ITEM 1.6

**85 Harrington Street  
The Rocks  
GOLDEN AGE & HANNAS THE ROCKS**

**RESPONSE TO DoPE  
ITEM 1.6**

**2** ELEVATION 201-312 Window Elevations  
1:50

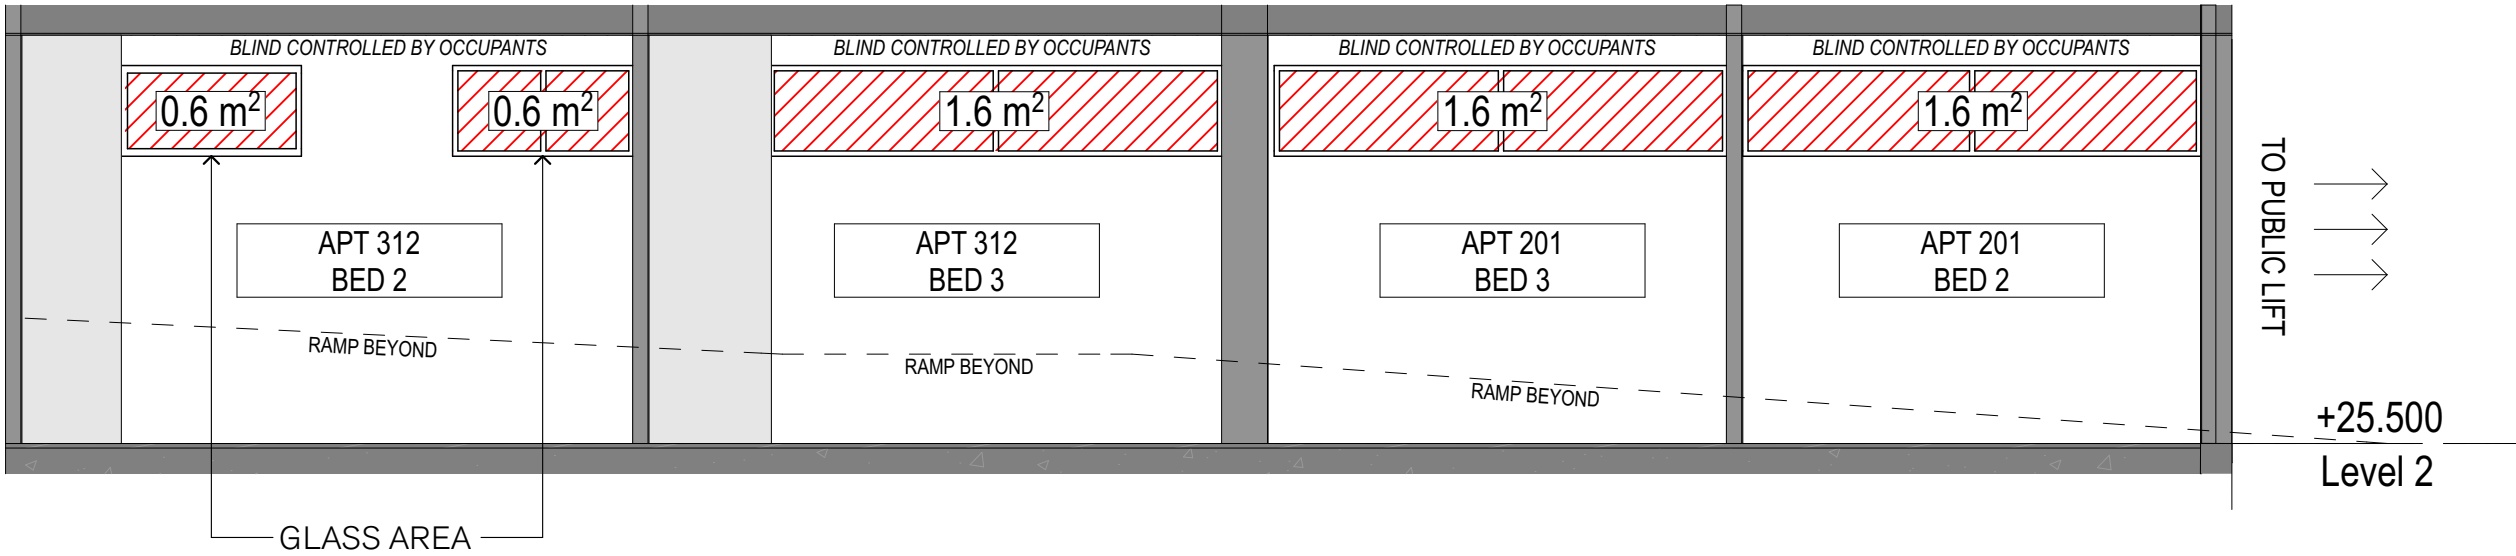
**Description:**  
In addition, confirm that windows serving north facing bedrooms in units 201 and 312 in Building 1 achieve a total minimum glass area of not less than 10% of the floor area of the room

**Response**  
Compliance is met with the windows servicing both 201 and 312 (Building 1) exceeding a glass area of not less than 10% of the floor area of the room.
